## **TECHNICAL SERVICE BULLETIN**

TSB-001-2016-008

Subject: handle adjusting gear improvement Date: Oct/18/2016

SITUATION INVOLVED MACHINES: AS380B, AS380C

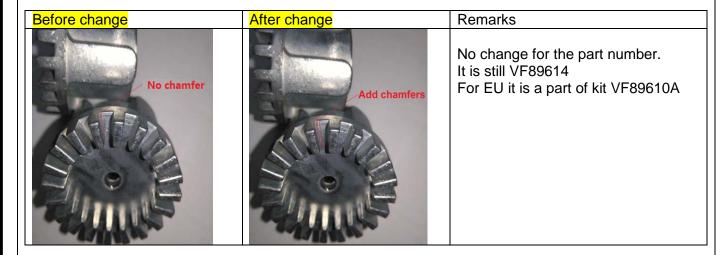
Dir-casting gears for handle adjustment were breaking

Small teeth were broken and removed.

Design issue. There are no chamfers on the lower edges of the gear teeth.

To make the teeth stronger, we have added chamfers to every lower edge of the gear teeth.
